APPLICATION NO.	FILING DATE	FIRST NAMED INVENTOR	ATTORNEY DOCKET NO.	CONFIRMATION NO.
10/541,193	06/30/2005	Lutz Konrad	KIRS.0022	7743
38327	7590	08/28/2007	EXAMINER	
REED SMITH LLP			MITCHELL, KATHERINE W	
3110 FAIRVIEW PARK DRIVE, SUITE 1400			ART UNIT	PAPER NUMBER
FALLS CHURCH, VA 22042			3677	
MAIL DATE		DELIVERY MODE		
08/28/2007		PAPER

Office Action Summary	Application No.	Applicant(s)	
	10/541,193	KONRAD ET AL.	
	Examiner	Art Unit	
	Katherine W. Mitchell	3677

DETAILED ACTION

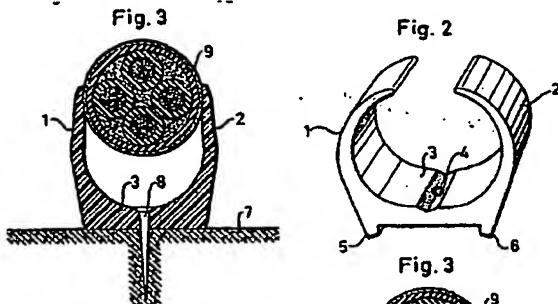
Regarding claims 6, 7 and 18-23 – examiner is not clear on what the zones are.

The specification just repeats the wording in the claims. How is a zone different from a side face (6,7)? Examiner is interpreting this based on Figs 1 and 2.

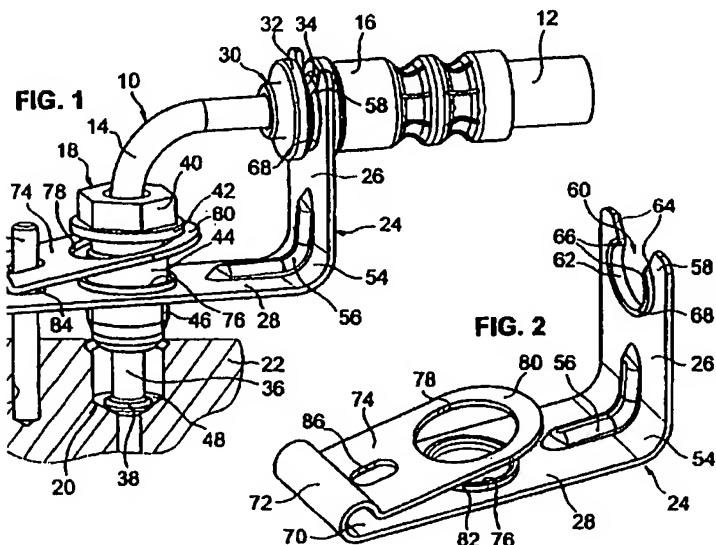
5. Claims 1-5 and 11-17 are rejected under 35 U.S.C. 102(b) as being anticipated by Loof, GB 894867 or in the alternative, rejected under 35 U.S.C. 103(a) as obvious over Loof. Loof teaches per the figures below a fastener with a clip (1,2,3, with a clip base (3,5,6) and a fixing element (nail 8) in a throughbore 4 in the base, and the longitudinal axis of the fixing element 8 runs through the clip opening. Loof teaches that the clip is a resilient material, which according to US Drawing legends is plastic. However, if it is held that the legends do not inherently teach the resilient material is plastic, an alternative rejection is provided below.

Re claims 2-3,11: Fig 3 shows the fixing element press fit in the hole, and Fig 2 shows a recess for the head to completely fit into, per Fig 3.

Re claims 4-5,12,13,14,15,16,17 : The clip opening has 2 free ends as described, per Fig 3, and the inner contours is essentially circular and is capable of holding a wire.

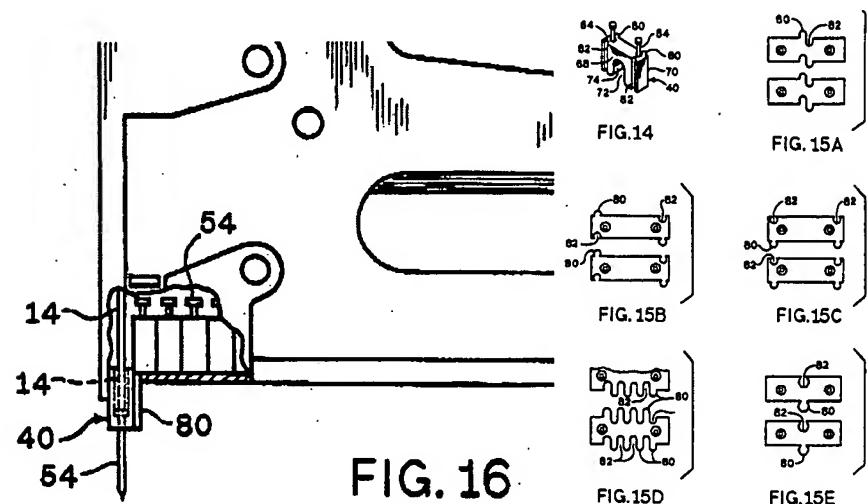
As discussed above, Loof teaches all the elements except chamfered ends. Capan teaches a clip with arms forming a circular recess for a pipe, usable obviously with cable, having ends beveled as disclosed to assist in insertion of the round pipe, per Figs below. It would have been obvious to one of ordinary skill in the art, having the teachings of Loof and Capan before him at the time the invention was made, to modify Loof to make the clip with chamfered insertion faces as is done by Capan, in order to obtain a a clip that allowed easy insertion with minimal force. One would have been motivated to make such a combination because chamfered ends are known and used to allow for slight misalignment when inserting items between two surfaces, and then center the item for easy insertion, and also prevents chipping as would be a problems with a sharp angled edge.

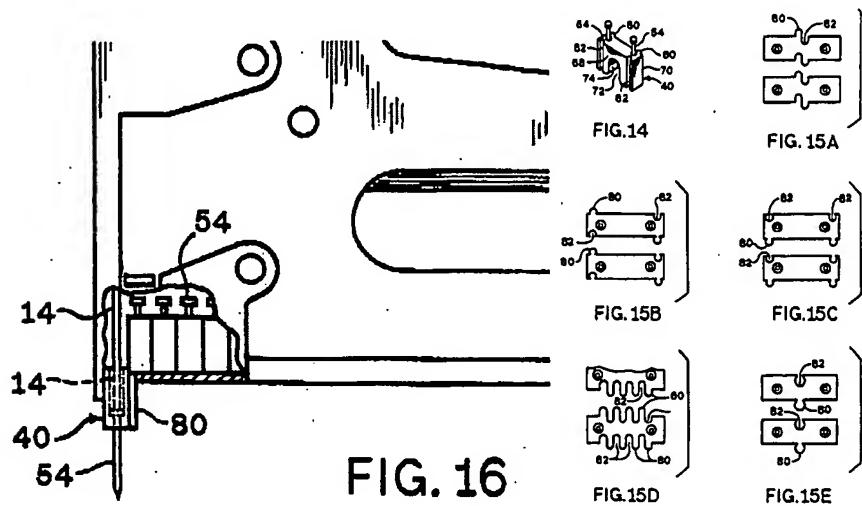
As discussed above, Loof in view of Capan teaches all the elements except multiple fasteners with inner contours of the clip bores aligned, and that said multiple fasteners are joined together by at least one predetermined breaking web extending longitudinally between adjacent outer fastener faces. Erickson teaches multiple fasteners used as cable/wire clips, with aligned inner contours and a longitudinally extending connecting web, in the figures copied below.

As discussed above, Loof teaches all the elements except multiple fasteners with inner contours of the clip bores aligned, and that said multiple fasteners are joined together by at least one predetermined breaking web extending longitudinally between adjacent outer fastener faces. Erickson teaches multiple fasteners used as cable/wire clips, arranged to be capable of use with a magazine housing in such a way that a feed device (gun) can eject the fasteners such that the arrangement moves forward to a feed end of a gun with an opening at right angles to the longitudinal direction, as in the figures copied below.
